The following items are conditions for permit issuance and strict compliance is mandatory.

# VAULTED END WALL DETAIL

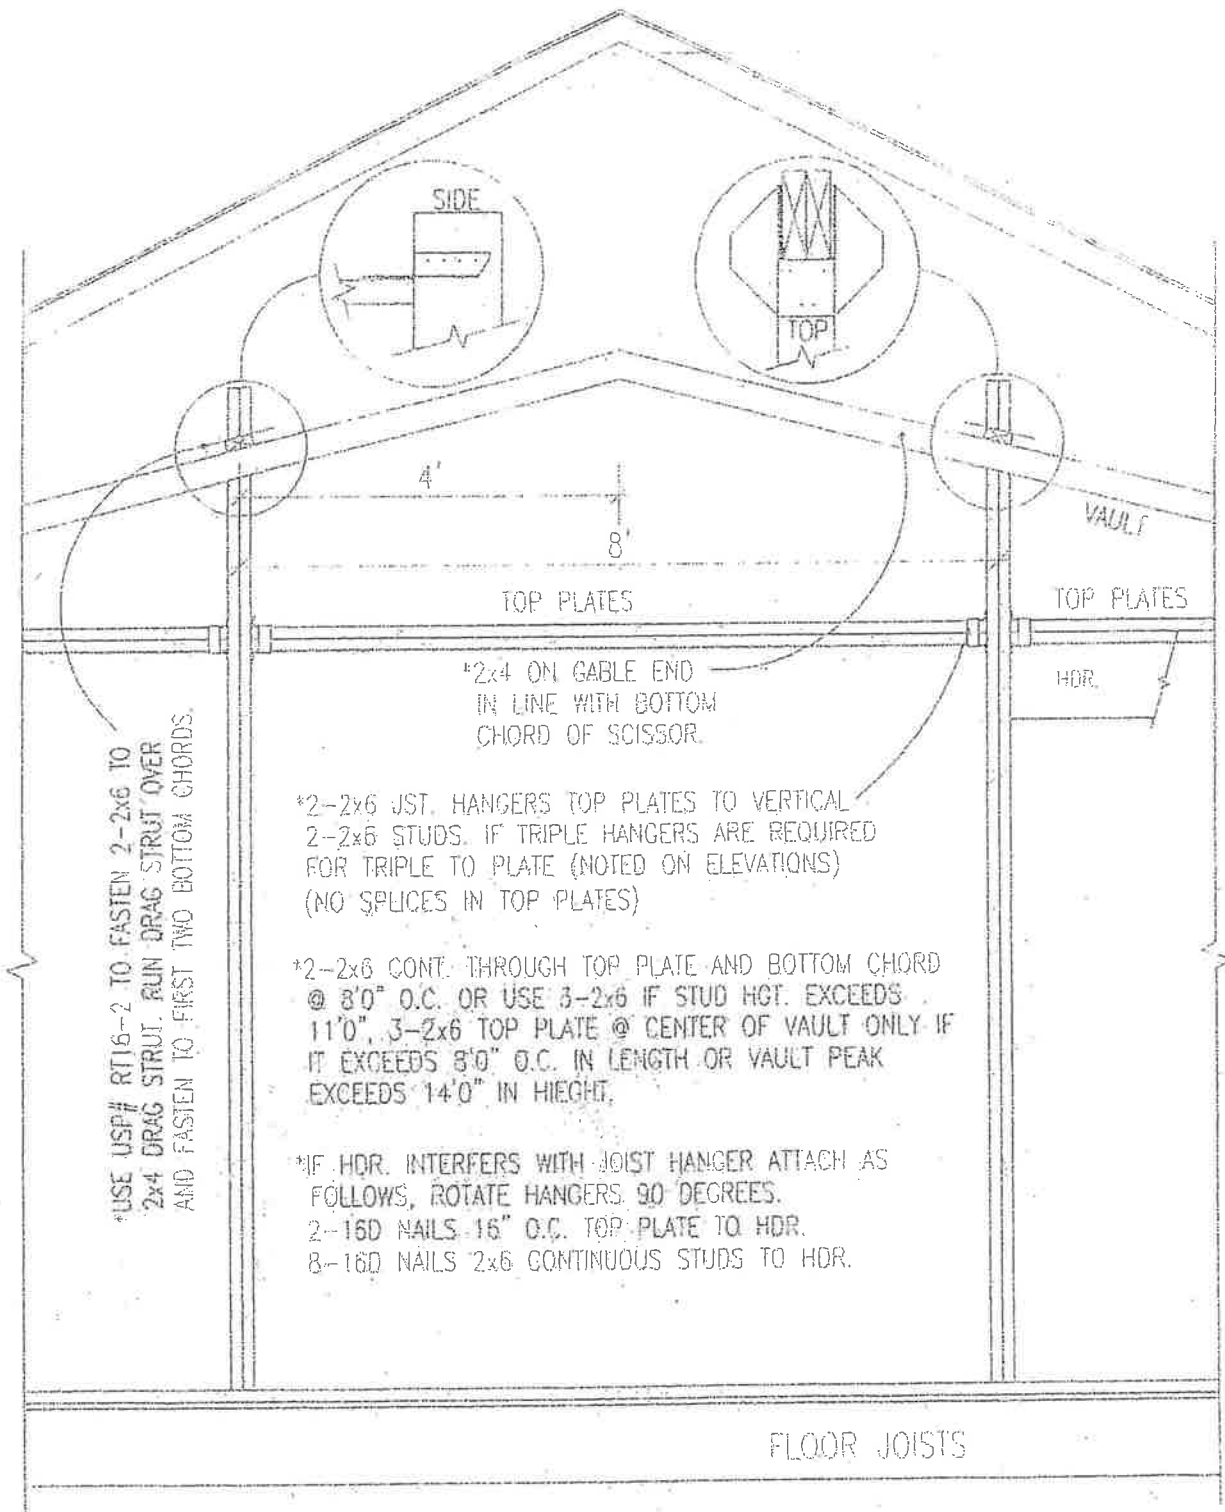
13. Vault walls shall be balloon framed or have King posts installed in them. (see attached)

Figure 1. Recommended construction details for APA portal frame bracing without hold-downs

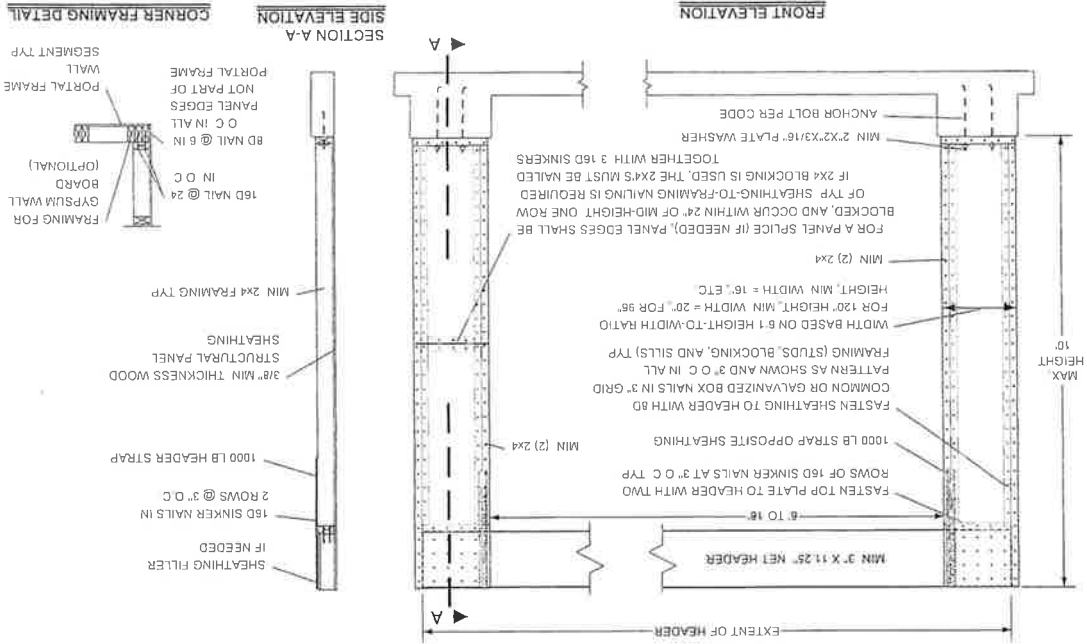
47. Install proper wind bracing. Bracing shall be designed for 115 mph wind load. MSBC1309/R301.2.1
